**From:** City of Ann Arbor Transportation Commission  
**Sent:** Wednesday, September 11, 2024 1:51 PM  
**To:** Cespedes, Christopher  
**Subject:** FW: Concerns about the proposed Pauline reconfiguration

I'm writing with some concerns about the proposed reconfiguration for Pauline between Seventh and Main, as depicted on this month's agenda.

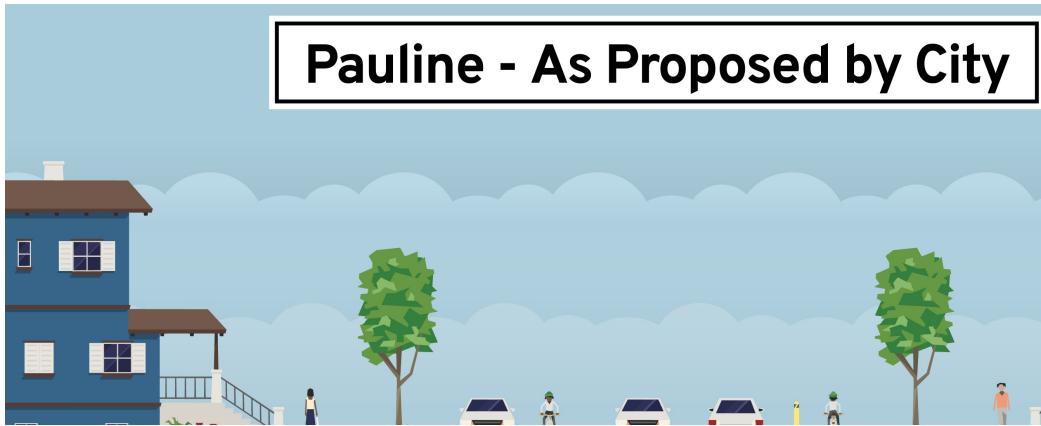
Unfortunately, this proposed design for Pauline seems to repeat many of the same problems seen in the rejected designs for South Seventh. Specifically, it will (1) exacerbate potential speeding issues by increasing the perceived width of the road for drivers, (2) oblige people to bike in the "door zone" of parked cars, and (3) compromise the effectiveness of curb extensions ("bump outs") while simultaneously making them problematic choke points for people riding bikes.

These first two problems could have been resolved by instead using a "parking-protected bike lane" design:

In this design, people riding bikes would have properly separated bike lanes on both sides of Pauline, as well as a proper buffer between the bike lane and car doors. Where present, parked cars would enhance

the separation between the bike lane and the road, and crucially, they would visually narrow the road for drivers.

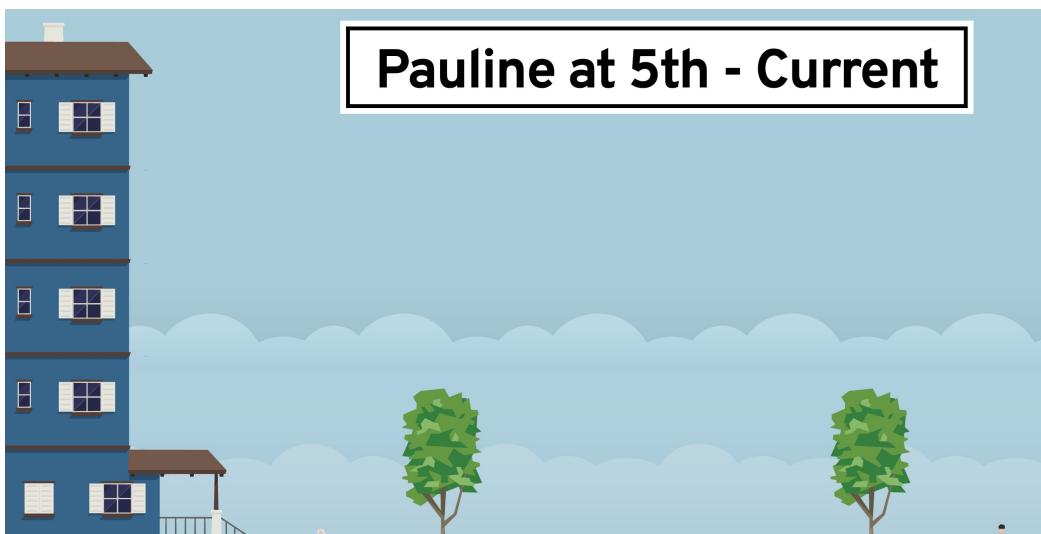
Contrast that with the city's proposed design for a door-zone bike lane with curbside parking:

In this case, the clear width between parked cars on one side and delineators on the other is significantly wider, and as a result could subconsciously encourage speeding. And of course, the bike lanes next to parked cars would place people in the "door zone" and provide no vertical separation from moving traffic.

## Pauline at 5th - As Proposed By City

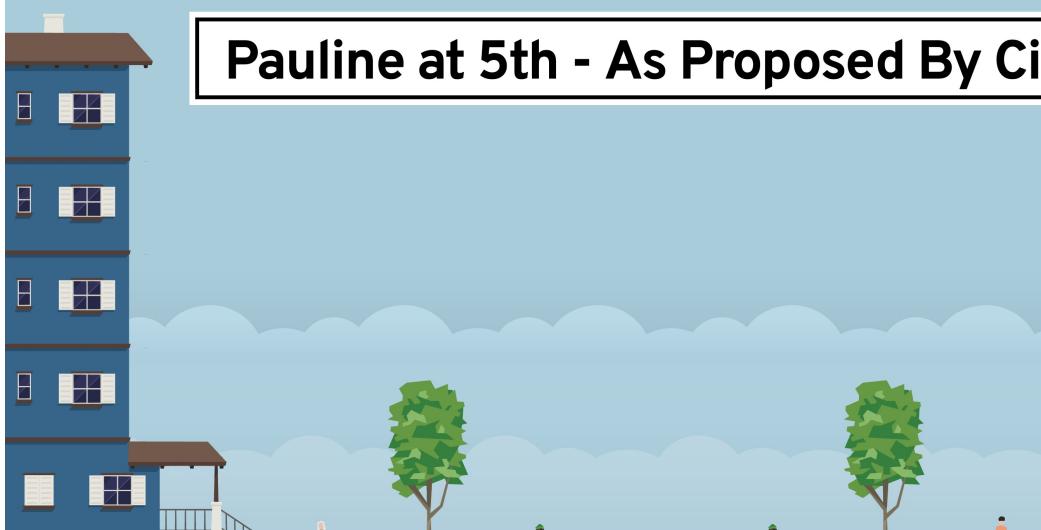
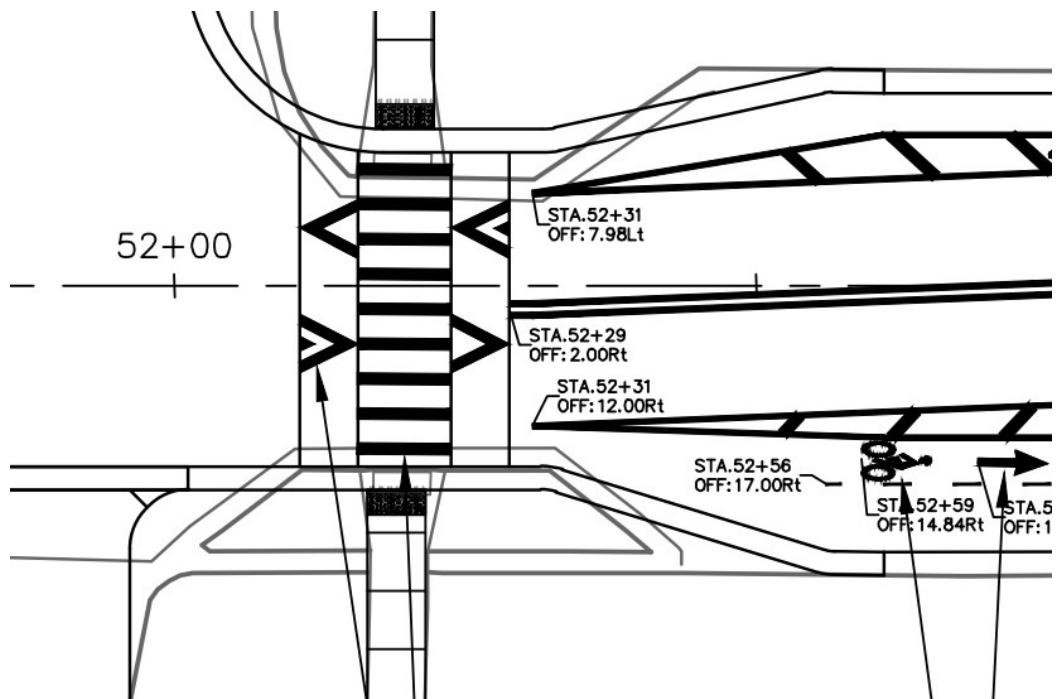
As for curb extensions, I think it's particularly notable that the plan for Pauline would actually *widen* the road and increase the pedestrian crossing distance at Pauline and 5th. An existing set of curb extensions makes the road quite narrow there:

However, the proposed design would actually widen this section to add (unbuffered, painted) bike lanes:

You can see this in the actual drawing provided by the city

(<https://a2gov.legistar.com/View.ashx?M=F&ID=13239848&GUID=DF1F42B7-9678-4846-9C07-799A3964983F>), which shows the existing curbline overlaid with the proposed new curbline:

This is a bad deal for everyone. By widening the road, it'll reduce the effectiveness of this curb extension as a "speed management" tool and increase the pedestrian crossing distance. At the same time, it creates a choke point for people riding bikes and removes their buffer/separation from moving traffic.

## Pauline at 5th - Sidewalk-level Bike L

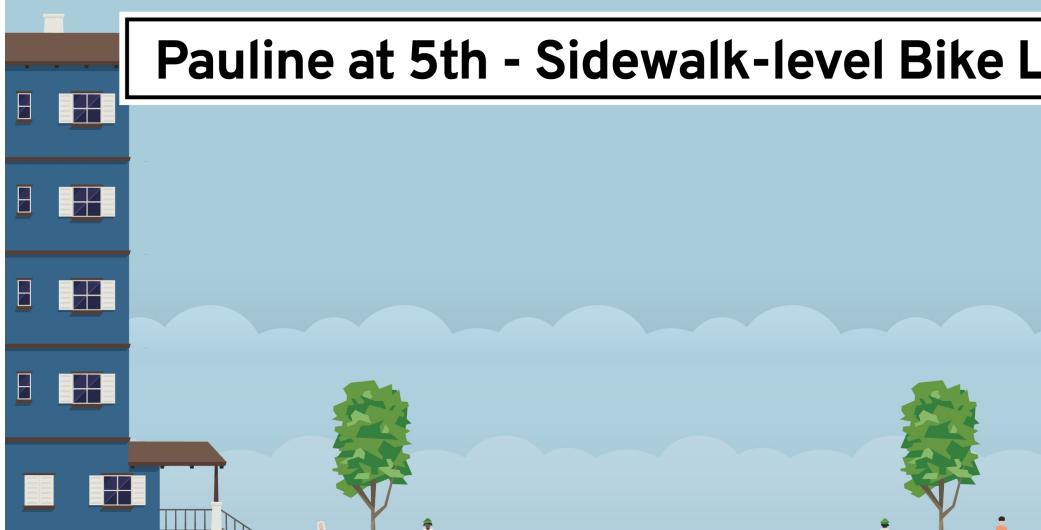
I believe that this bad compromise is an unnecessary one. We could instead keep the bike lanes separated from traffic by - for example - temporarily elevating them up to sidewalk level and setting them back a bit further from the roadway:

This would keep a narrow roadway for drivers and shorter crossing distances for pedestrians, while maintaining separation of the bike lanes. It's also an idea that has plenty of precedent in our city - it's very similar to the design approach we have employed for *every single roundabout* in the city:
